Re: PETITION NO. 1442 - SR Litchfield, LLC petition for a declaratory ruling, pursuant to Connecticut General Statutes §4-176 and §16-50k, for the proposed construction, maintenance and operation of a 19.8-megawatt AC solar photovoltaic electric generating facility on 6 contiguous parcels located both east and west of Wilson Road south of the intersection with Litchfield Town Farm Road in Litchfield, Connecticut, and both east and west of Rossi Road, south of the intersection with Highland Avenue in Torrington, Connecticut, and associated electrical interconnection

Partial Development and Management Plan II

**RESPONSES OF SR LITCHFIELD, LLC
TO CONNECTICUT SITING COUNCIL INTERROGATORIES
PARTIAL DEVELOPMENT AND MANAGEMENT PLAN II**

L101

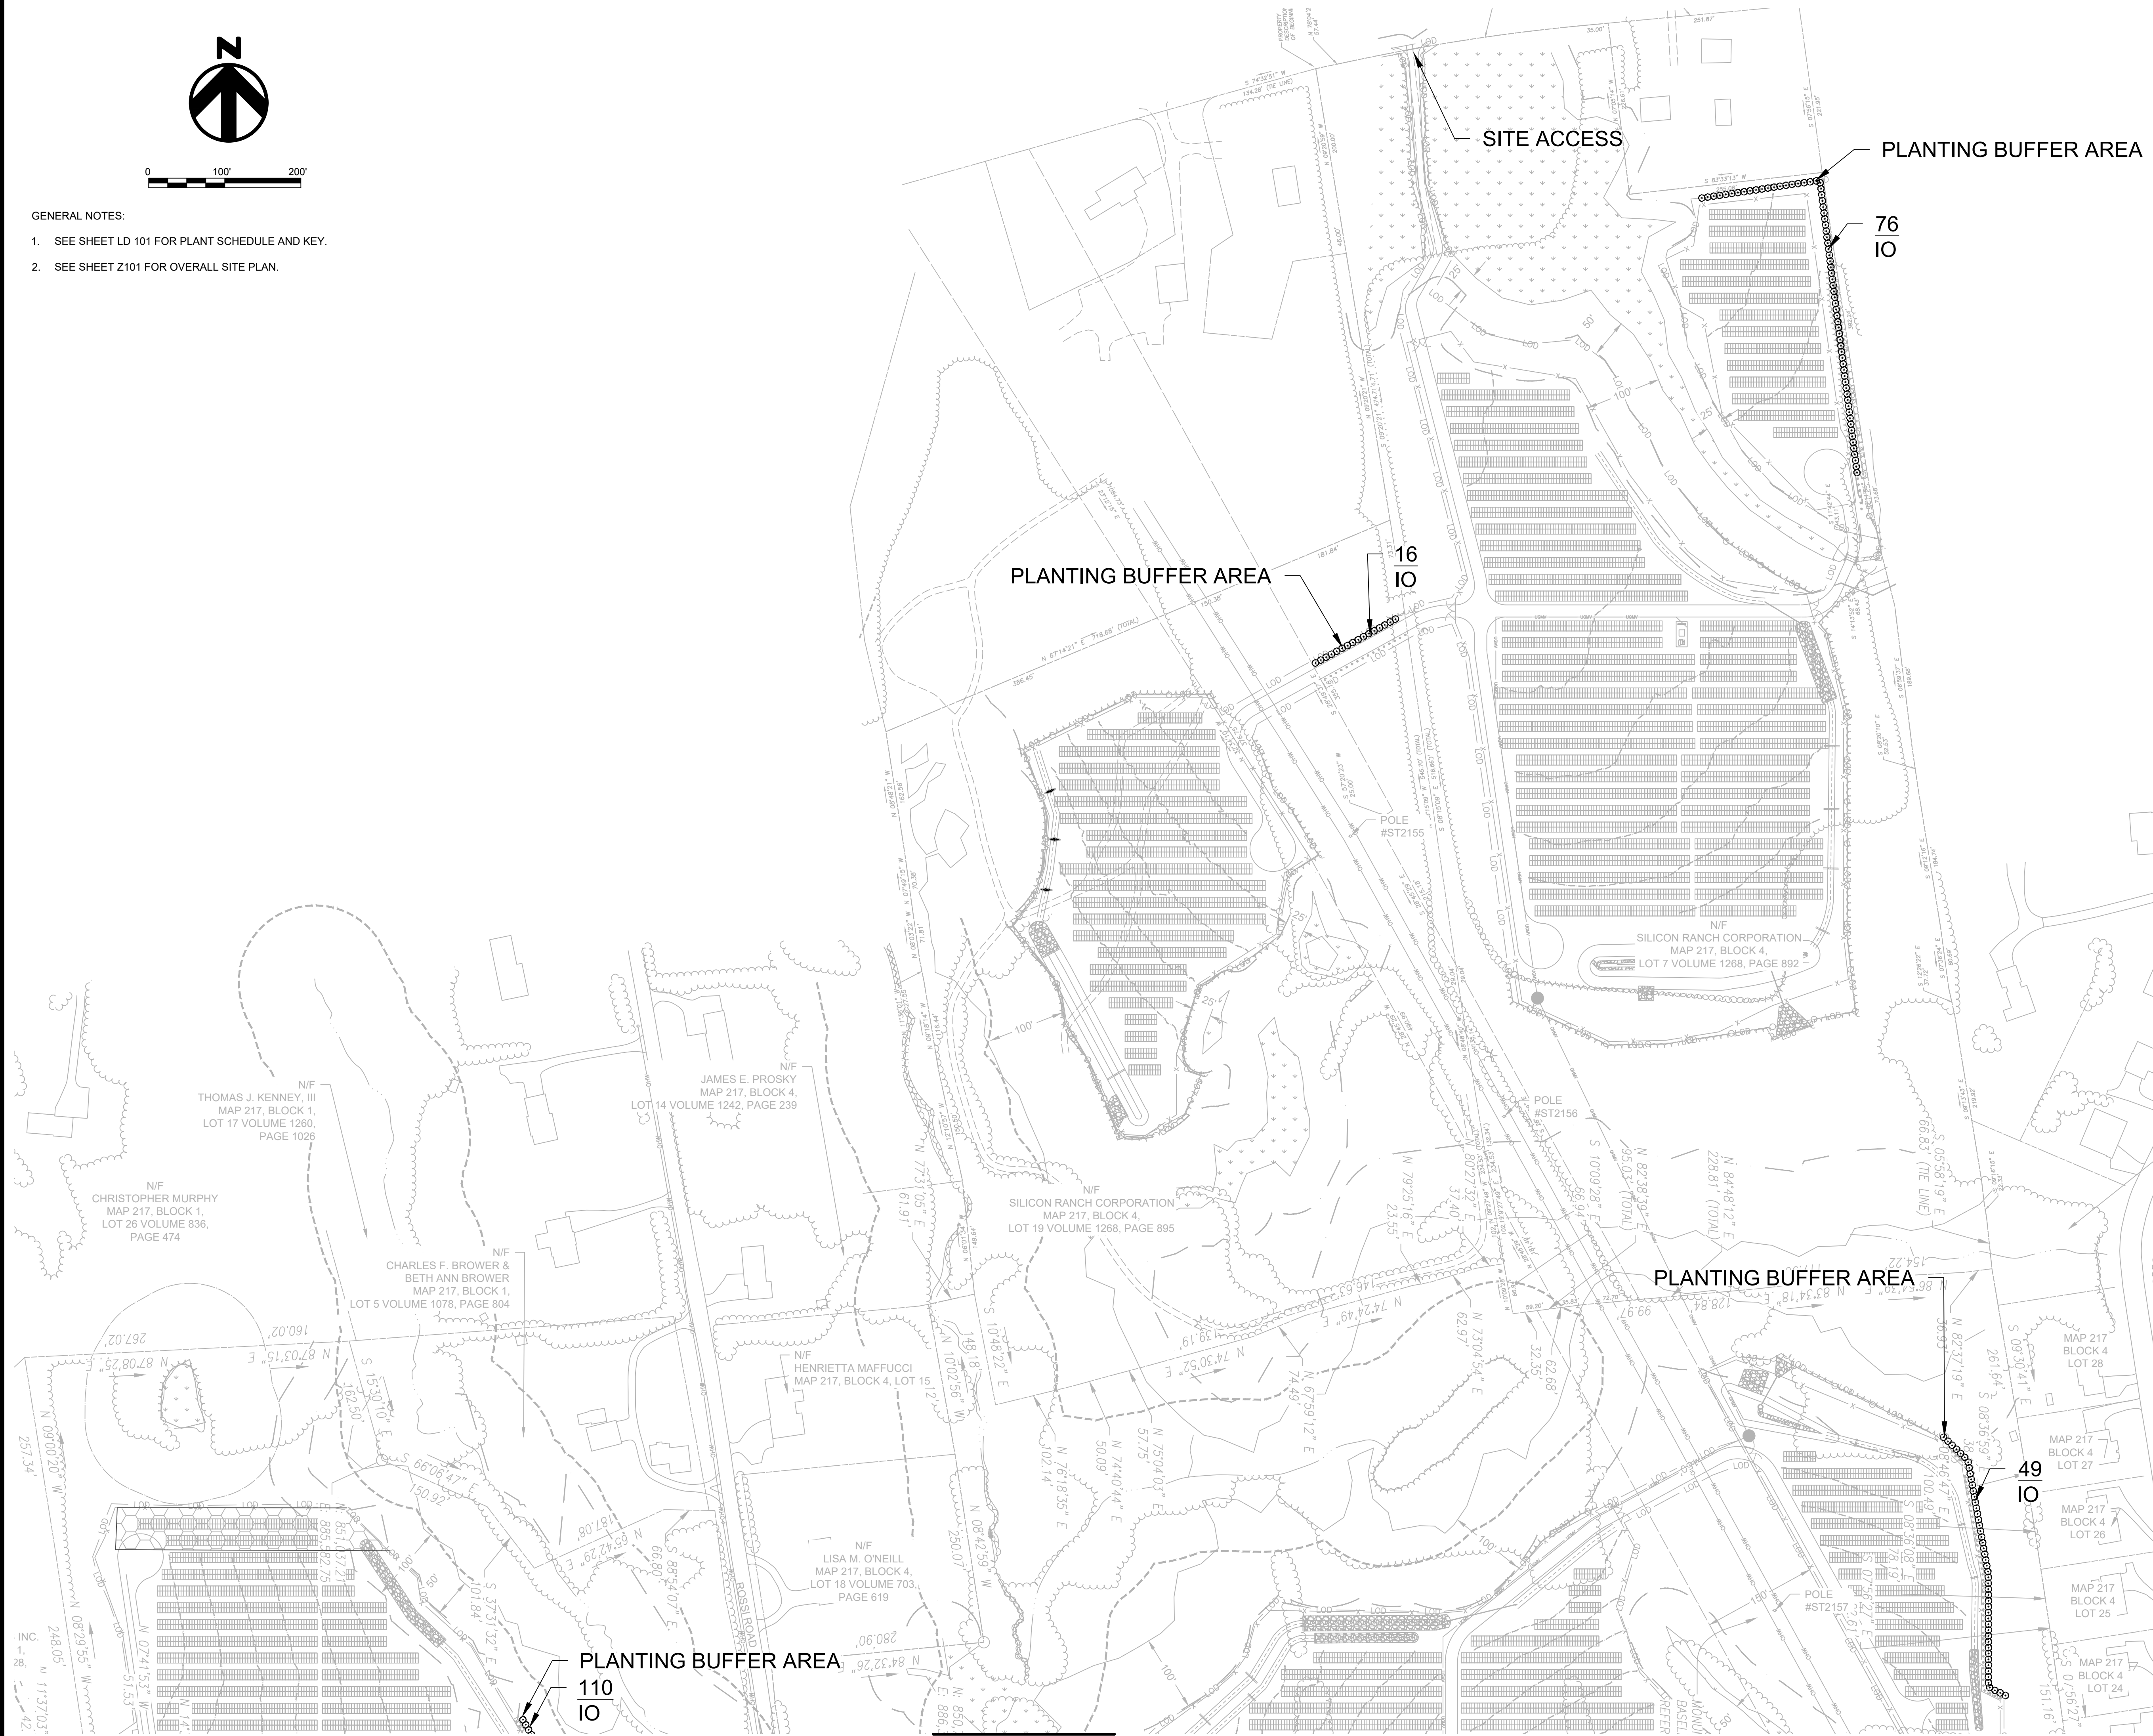
Can the fence be realigned in the following access road areas to eliminate barriers to large wildlife movement?

- a. Access road extending east from Wilson Road to “Area 2”.
- b. Access road extending from Highland Road to “Area 1”.

- a. The Landscaping Plans have been updated to include the fence marking (i.e., X—X) (see **Attachment A**). The fence is several hundred feet from Wilson Road and its location should allow movement of large wildlife in that area. Petitioner plans to install a bar gate where the access road meets Wilson Road to restrict unauthorized vehicular access.
- b. The Landscaping Plans have been updated to include the fence marking (i.e., X—X) (see **Attachment A**). The fence is several hundred feet from Highland Avenue and its location should allow movement of large wildlife in the area between Highland Avenue

and the fence. Petitioner plans to install a bar gate where the access road meets Highland Avenue to restrict unauthorized vehicular access.

LD101

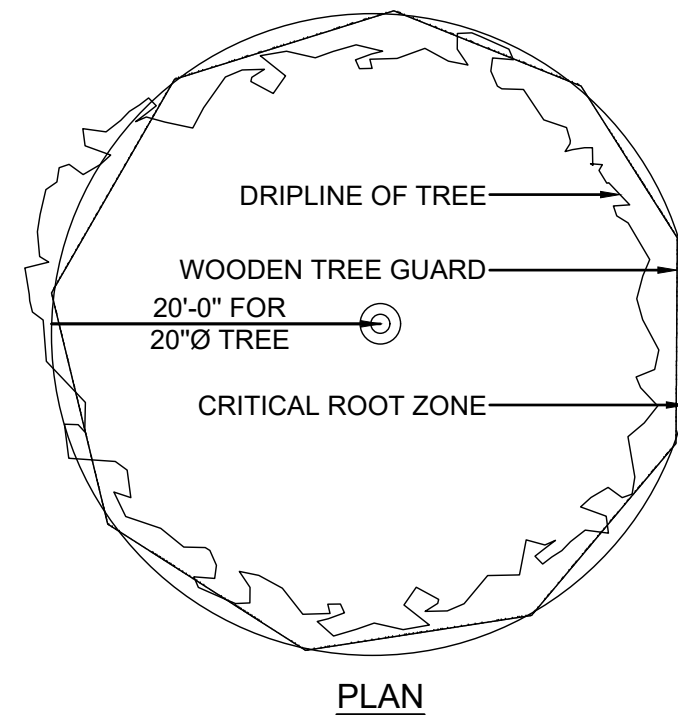
Referring to the Landscaping Plan Sheet LD-101 (Attachment B), the final seed mix specifies only turf grasses for the entire site. In the response to Petition Interrogatory 51, dated April 16, 2021, several types of seed mix were proposed for specific areas of the site such as a grass and forb pollinator mix, Northeast Solar Pollinator Buffer Mix, New England Conservation/Wildlife mix, New England Erosion Control/Restoration mix for Detention Basins and Moist Sites mix. Explain why only a turf grass mix is proposed for all areas of the site. Can low height wildflower species be incorporated into the solar field turf mix?

Landscaping Plan Sheet LD-101 has been updated to reflect the previous response to Interrogatory 51 (*see **Attachment A***).

2. PROVIDE THE FOLLOWING SEED MIXTURE:
 - A. AREAS WITHIN THE FENCED LIMITS OF THE SOLAR FACILITY:
SOLAR SEED MIX ERNMX 146 OR ERNMX 147 OR APPROVED EQUAL

- B. AREAS OUTSIDE THE FENCE THAT ARE DISTURBED DUE TO CONSTRUCTION ACTIVITIES:
NORTHEAST SOLAR POLLINATOR BUFFER MIX ERNMX 610 OR APPROVED EQUAL
 - C. AREAS IN BASINS, SWALES, OR OTHER STORMWATER FEATURES:
NEWP NEW ENGLAND EROSION CONTROL/RESTORATION MIX FOR DETENTION BASINS AND MOIST SITES OR APPROVED EQUAL

VEGETATIVE BUFFER DETAIL

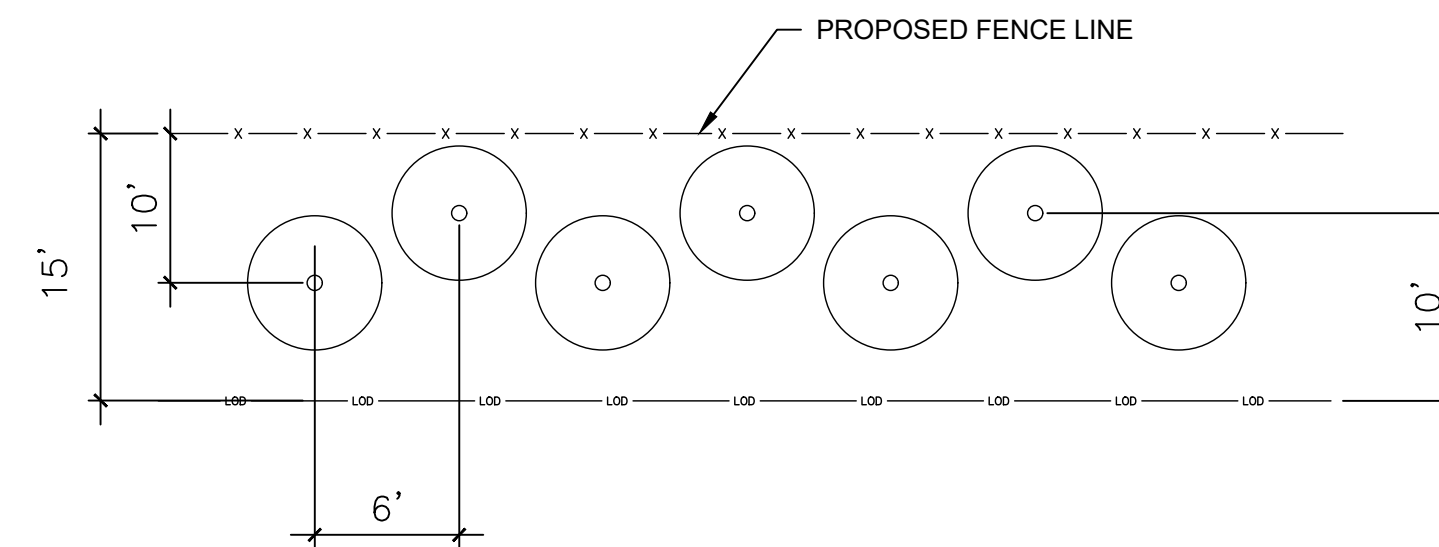
Referring to the Landscaping Plan Sheet LD-101 (Attachment B), will the American Holly be 15 feet in height at planting? In the response to Petition Interrogatory 54, dated April 2, 2021, the plantings were to be installed in staggered arrangement; however, the landscape plan shows a linear arrangement. Explain.

The scale of the plan sheets is too small to demonstrate the staggered planting. However, the Vegetative Buffer Detail on Landscaping Plan Sheet LD101 has been updated to show the

staggered plantings (*see* **Attachment A**).
